March 27, 1998

TO: Hamilton County Drainage Board

RE: Marion Blanton Drain

Project: **Bear Slide**
 Jackson Township
 Hamilton County, Indiana
 Title: **Grading Plan**
 North Area

M.L. Blanton Drain Relocation

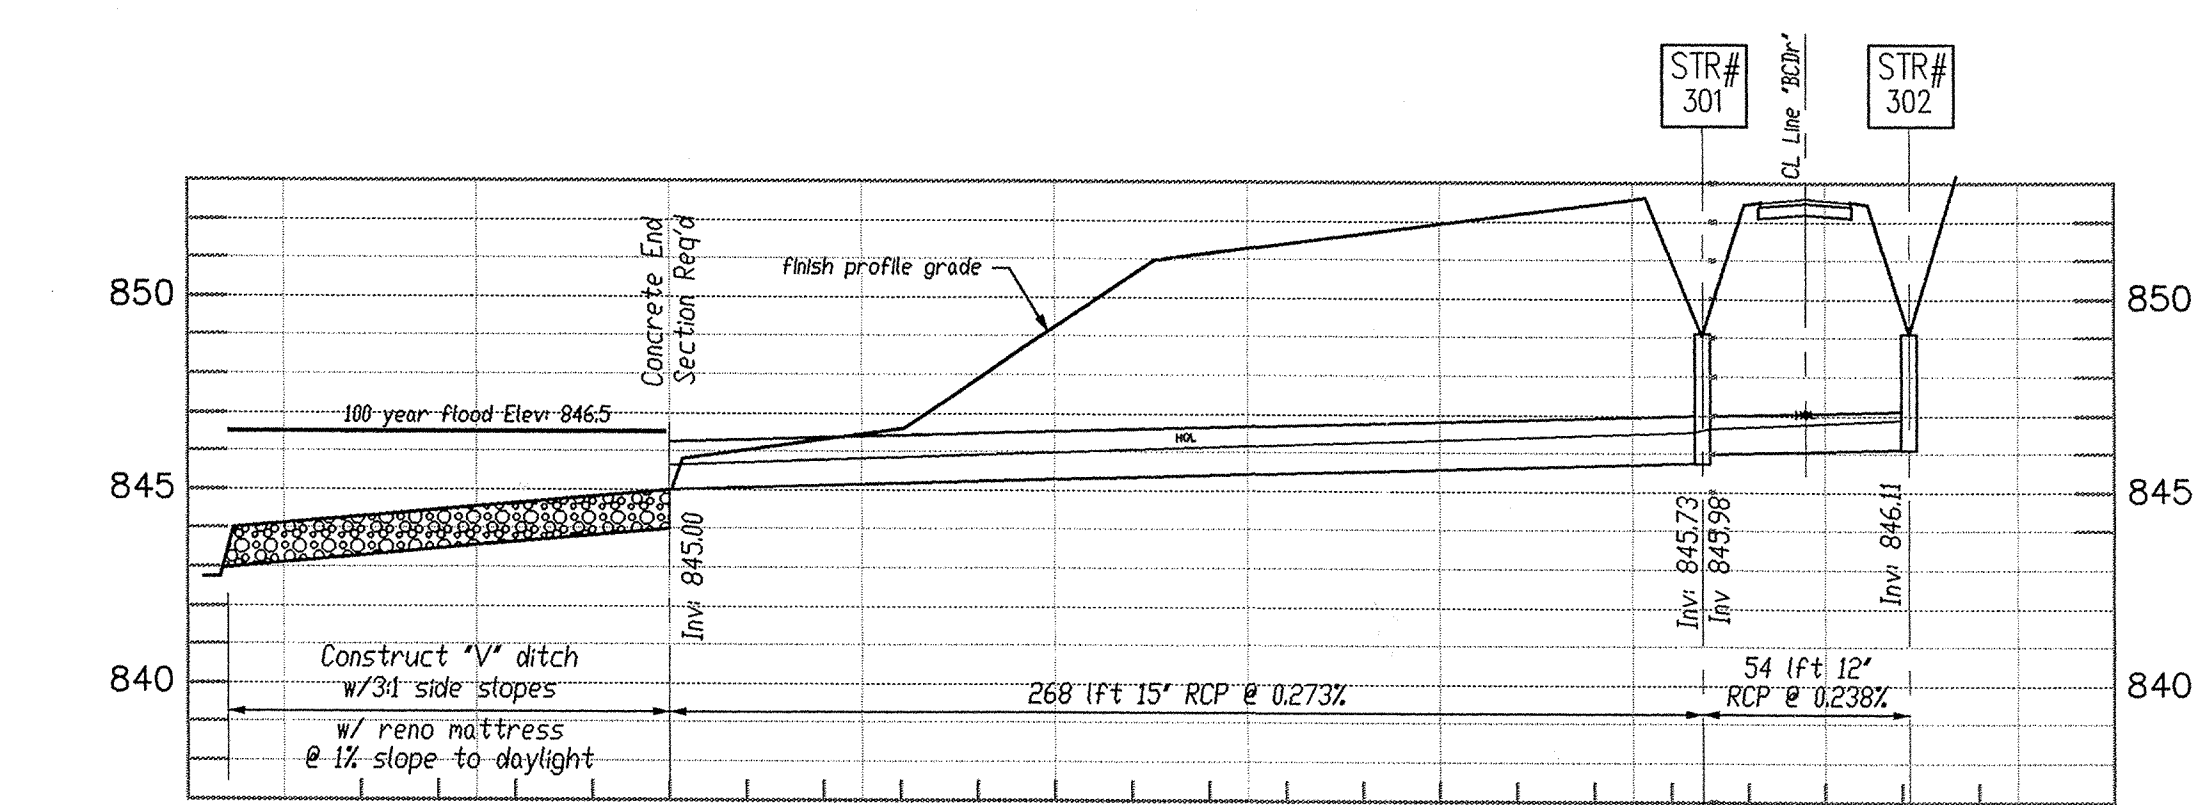
Attached is a petition and plans for the proposed relocation of the Marion Blanton Drain. Mahogany Holding Company is petitioning the relocation. The proposal is to reroute the existing tile drain by outletting the drain into a new open ditch at approximately STATION 113+90. The new open ditch shall run South parallel to the Right of Way of Mill Creek Road for distance of 478 feet and terminate in the John Caraway Arm.

The total length of new drain shall be 478 feet. The 690 feet of original drain between STATION 113+90 and STATION 120+80 shall be vacated. This proposal will decrease the drains total length by 212 feet.
